## SERVICE BULLETIN MAINTENANCE OF WAY EQUIPMENT

**BULLETIN NO:** 18-006

**TITLE:** Replacement of Network adapter

**PRODUCT SERIES / MODEL:** ProAccess PT-0310

FIGURE 1  
PT-0310 UNIT

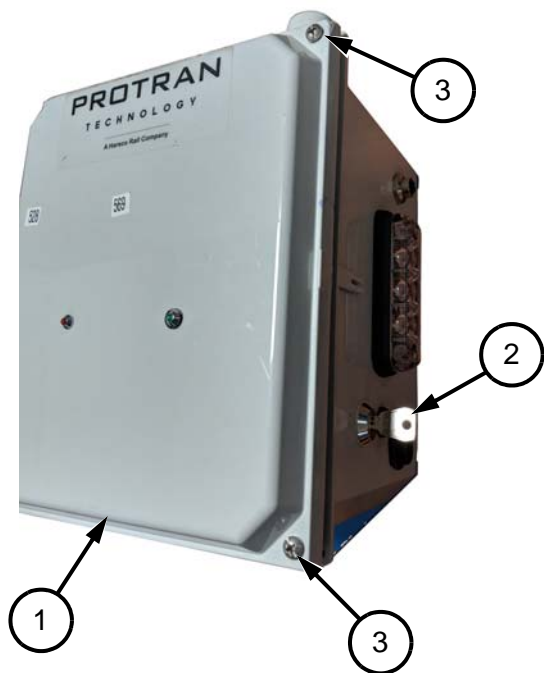
**SUMMARY:** Protran Technology has found an issue with the setup of the network adapters in the PT-0310 products. If Dynamic Host Configuration Protocol (DHCP) is enabled when a Static IP Address is used, there is a chance the unit will not use the Static IP Address. This causes problems in tightly controlled networks in which the subnet masks and IP Address are tightly restricted. In order to correct this problem, the PT-0310 will need to be powered down and connected to a system that has DHCP enabled. The User can then go into the configuration settings and disable the DHCP to allow the system to run off the assigned Static IP Address.

**ACTION:** Replace the properly configured network adapter inside the PT-0310 unit, or replace the entire PT-0310 with a new unit (not recommended).

1. Use key (2) to turn off power to the PT-0310 unit. Green LED on box will go off.
2. Open the PT-0310 by unscrewing the two faceplate screws (3) on the front side of the unit.
3. Disconnect the internal network cable (5) from the network adapter (4).
4. Remove the four screws (6) on the corners of the network adapter (4) and remove the adapter.
5. Install new network adapter and ensure the orientation is correct and that the pins seat properly.
6. Make sure the screw holes align properly with the mounting studs.
7. Secure adapter in place by reinstalling four screws (6).

**Note:** Torque for tightening screws is 10 in-lbs or hand tight and then 1/4 turn.

8. Attach the network cable (5) to the newly installed adapter.
9. Close the box and make sure the cover is tightly secured with two faceplate screws (3).

**Note:** Torque for tightening faceplate screws is 20 in-lbs or hand tight and then 1/2 turn.

10. Turn the key (2) switch to turn the PT-0310 unit back on. The Green LED will be illuminated.
